AMENDMENT OF SOLICITATION/MODIFICATION OF CONTRACT			1. Contract Number	Page of Pages 1 1
2. Amendment/Modification Number DCFL-2010-B-0162-002	3. Effective Date 16-Aug-10	4. Requisition/Purchase Request No.	5. Solicitation Caption DOC Structural Exterior Renovations

14. Description of amendment/modification (Organized by UCF Section headings, including solicitation/contract subject matter where feasible.)				
1. Questions and Answers is hereby incorporated as (Attachment A).

2. Page 5 of the subject solicitation is hereby revised to add Section B.9, ADD ALTERNATE THREE (See Attachment B).				
3. Sketch for Add Alternate Three is hereby incorporated as Attachment J.1.7.

OTHER QUESTIONS / COMMENTS / CLARIFICATIONS

SKETCH FOR ADD ALTERNATE THREE

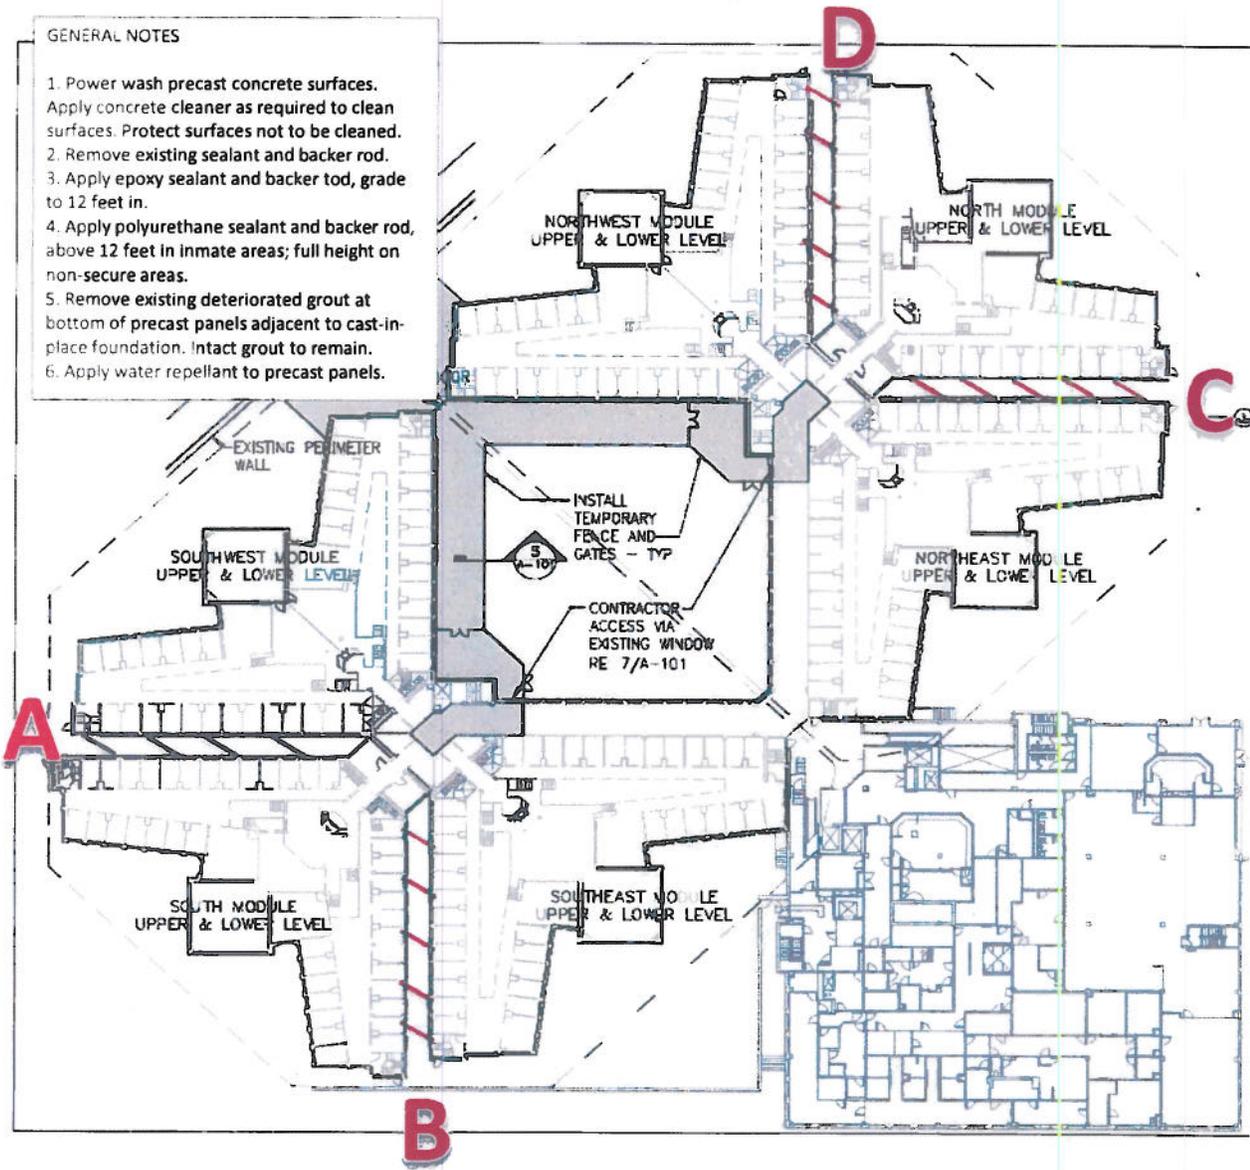
10. How should we price the slot areas that were identified at the pre bid walk thru (between NE/N, NW/N, SW/S, SE/S)

Response: There are 4 building “slots” between the South Housing units and the SE and SW units (then the same of the North). These are the approximately 10’ wide slots between the wings. These areas will need to be cleaned and sealed (waterproofed and caulked) only. The approximate square footage of these surfaces is 30,450. There are approximately 8 elevations similar to 3/A201 in the slots and 4 elevations similar to 6/A201 in the slots.

The contractor shall provide the cost for the renovation work of these surfaces as discussed during the site visit. The price is included in **add alternate three**, and should not be included as part of base bid. Refer to the new CLIN 004 issued. Also, a housing unit floor plan is attached for reference.

<u>CLIN</u>	<u>DESCRIPTION</u>	<u>LUMP SUM PRICE</u>
0004	Complete renovation work at the 4 “slots” Labeled A-D on the attached sketch. The approximately square footage of these surfaces is 30,450.	\$ _____
